ADDENDUM #1
Boulder County Parks and Open Space
Anne U White Trailhead Reconstruction and Stream Stabilization
BID # 7051-19

August 1, 2019

ANNE U. WHITE TRAILHEAD RESTORATION AND OPEN SPACE
SOIL LIFT SECTION LOCATIONS

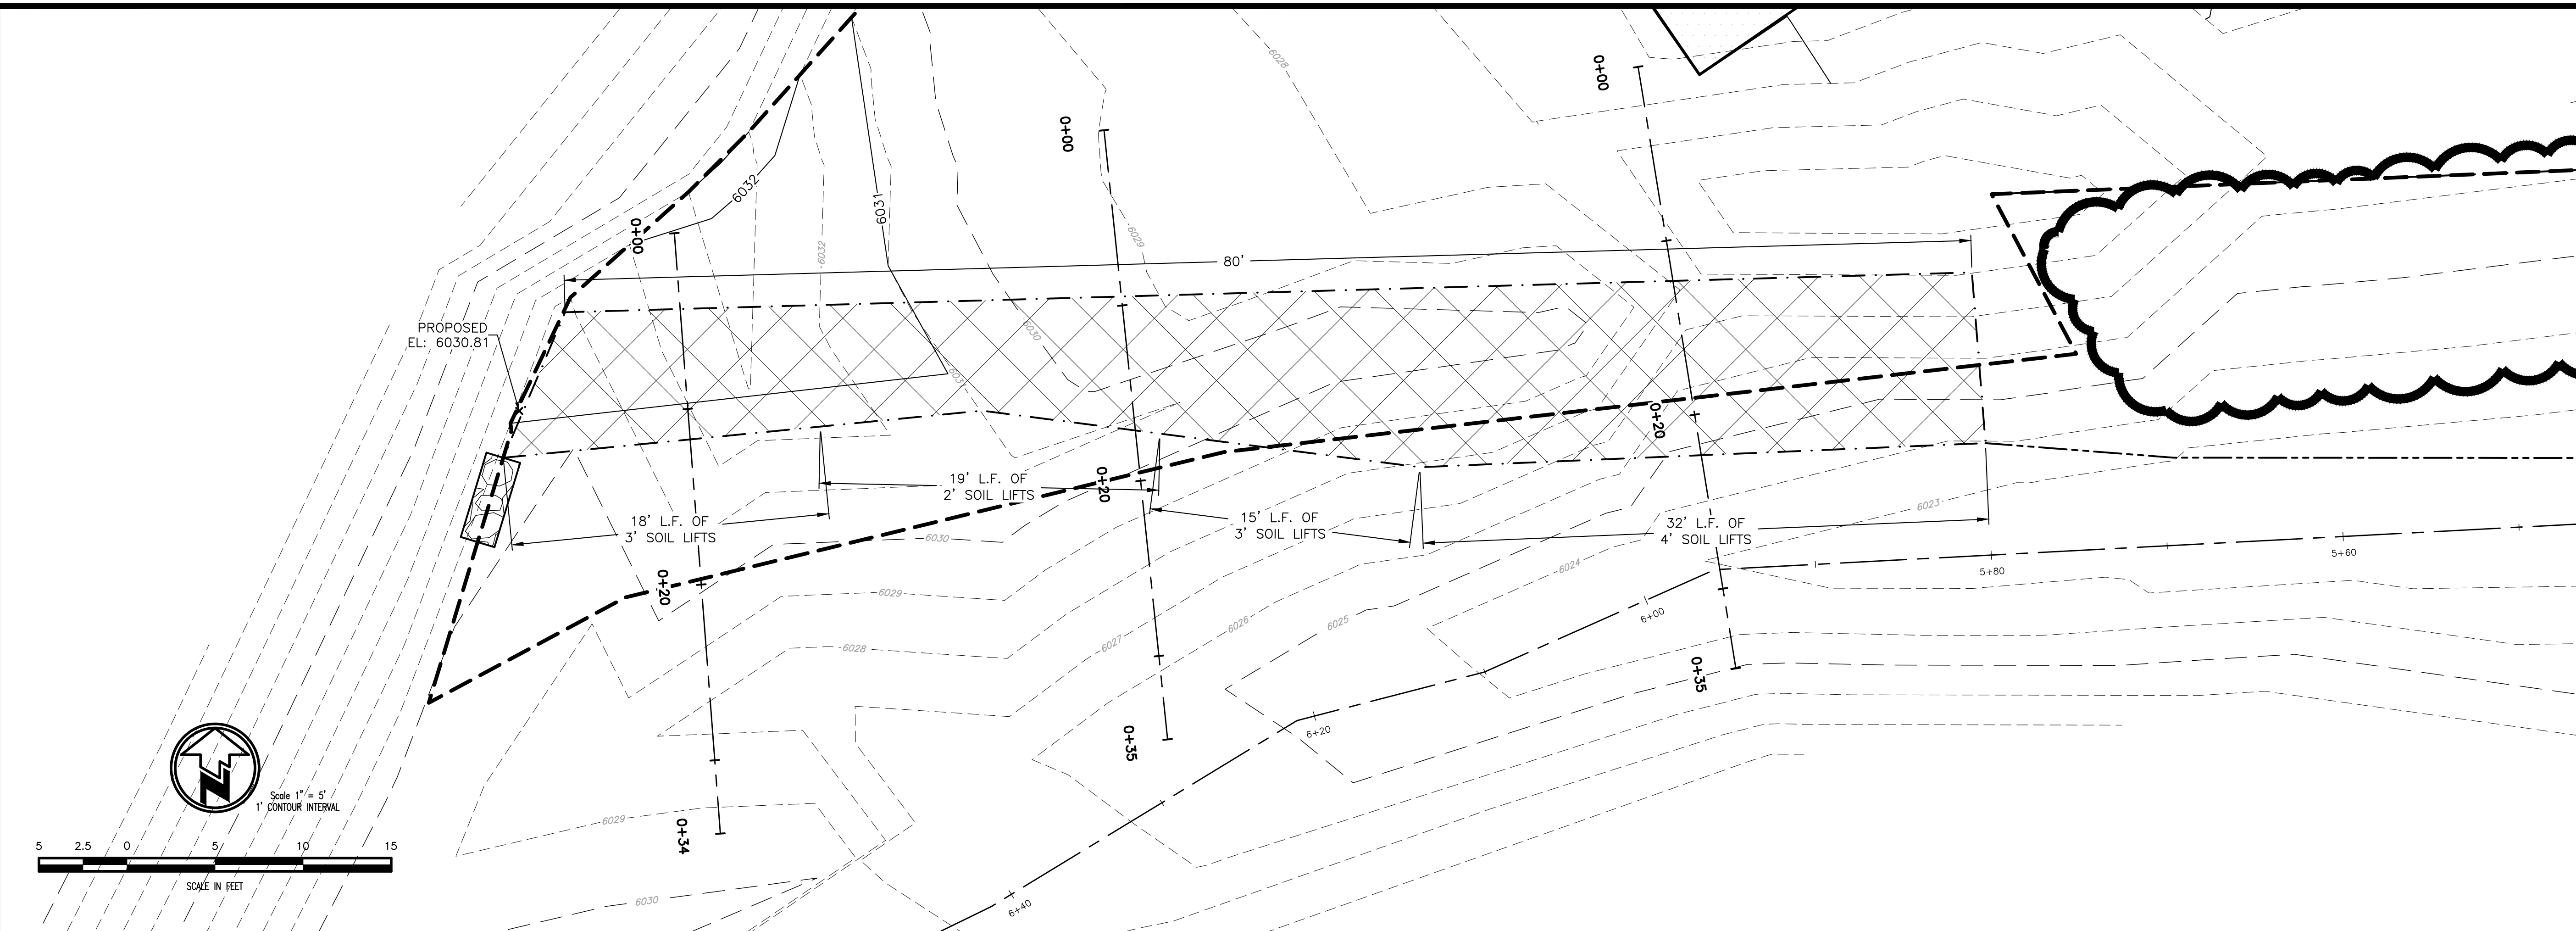
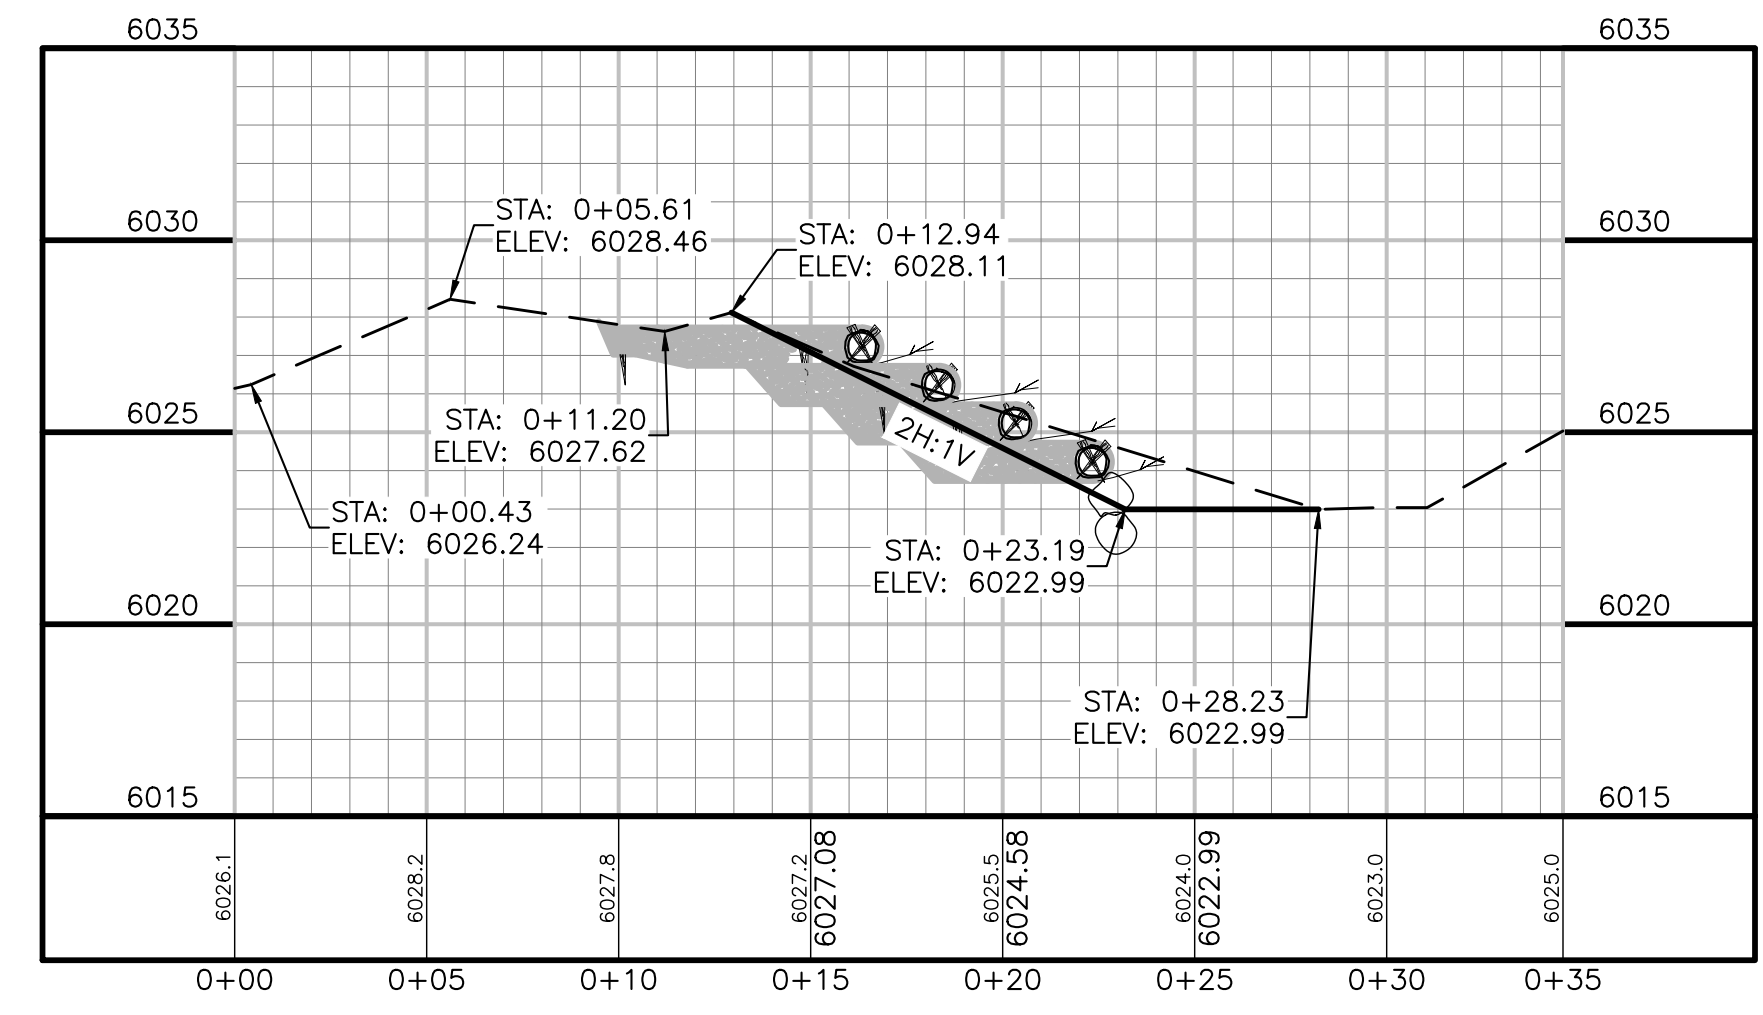
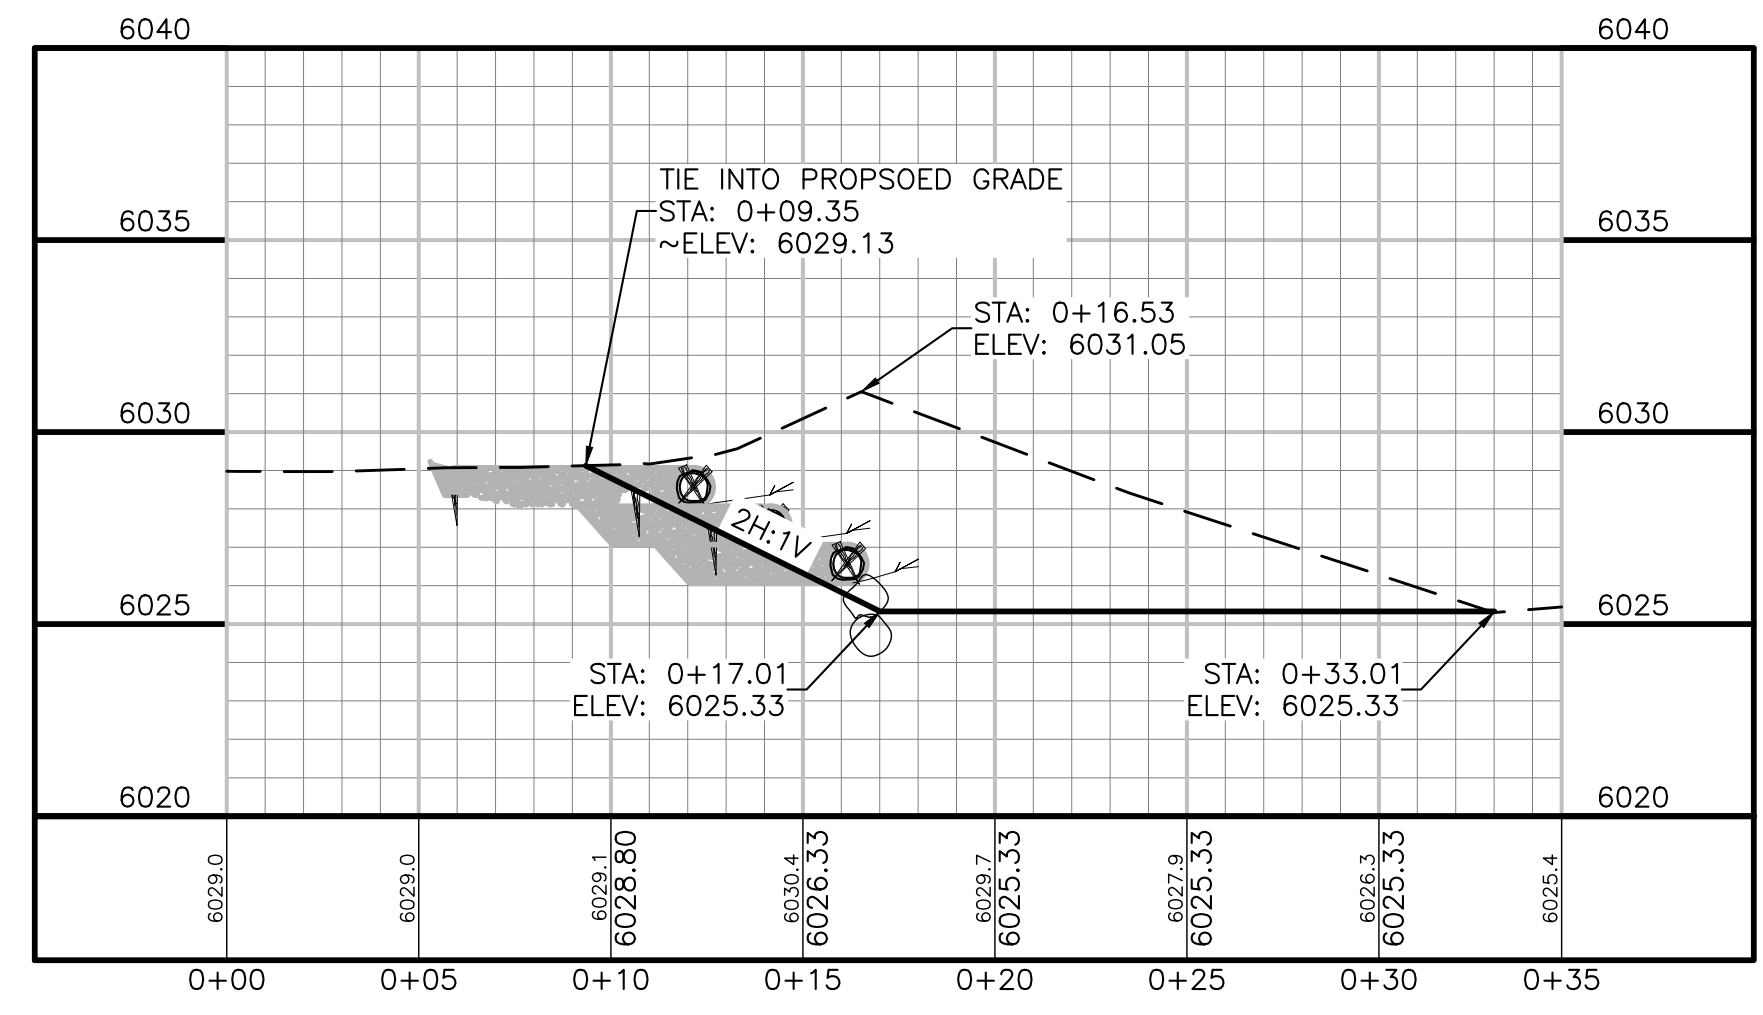
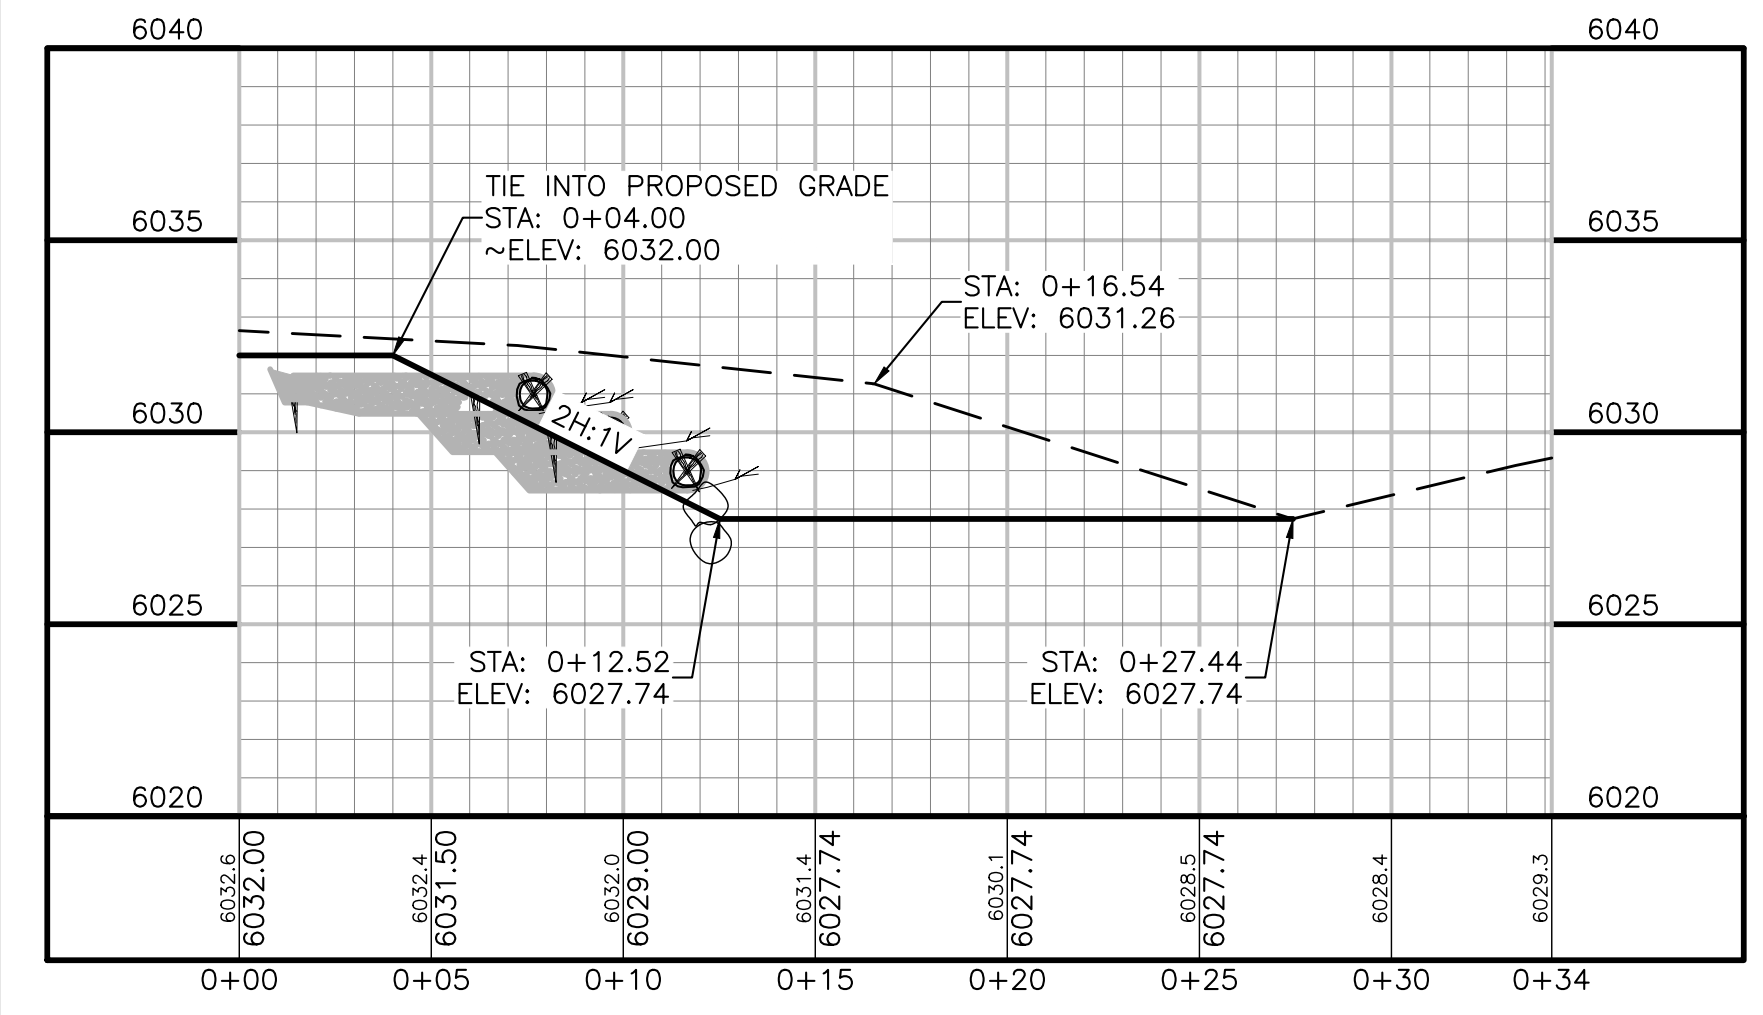
11. Will Boulder County provide additional details about the installation of the soil lifts?

ANSWER: The design engineer has provided an updated detail for the soil lifts which is included in this addendum. In addition, the contractor will import road base and top soil to be mixed (75/25) and used in the installation of the soil lifts to supplement the native material.
